Staff Report

Date: August 23, 2023
To: **Devens Enterprise Commission**
From: Neil Angus, DEC Director
RE: **34 Walnut Request for Certificate of Hardship for Roof Replacement**

Owner/App.: Ken Ashe
Location: 34 Walnut Street, Devens, MA
Zoning: Residential I and Devens Historic District

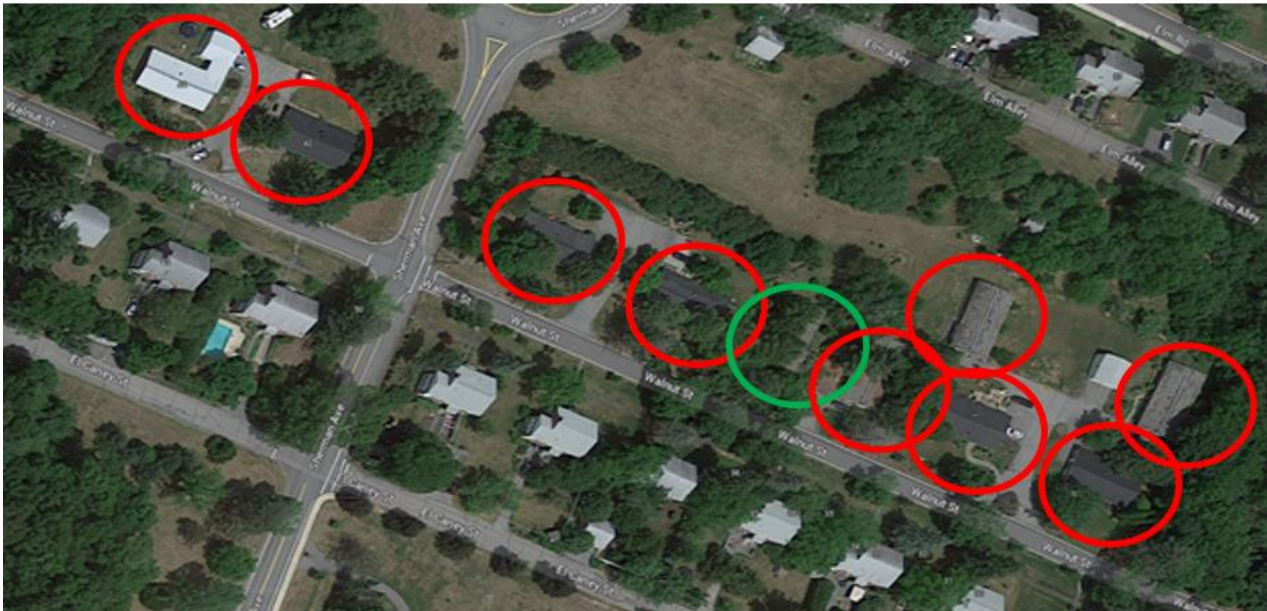
The owner of 34 Walnut (area circled in green in the picture above) is requesting to replace the existing tar and gravel roof with asphalt shingles. In accordance with the Historic District Regulations, he submitted a Project Notification Form to MHC in October of 2022 and MHC determined that such a modification would have “an adverse effect” on the Devens Historic District. The letter goes on to state that Fort Devens was planned and constructed with certain building types that contribute to its uniformity as a planned development. The letter also states that “...asphalt shingles are not designed to be installed on low-pitch roofs. On a lower slope roof, asphalt shingles may collect water beneath the shingles. Low sloped asphalt shingle roofs are susceptible to wind-driven rains, leaks and ice dams.” Staff also reviewed this request with our Building Commissioner who stated that from a purely building code perspective, while shallow roofs CAN be shingled, it is not advisable. The MA building code states asphalt
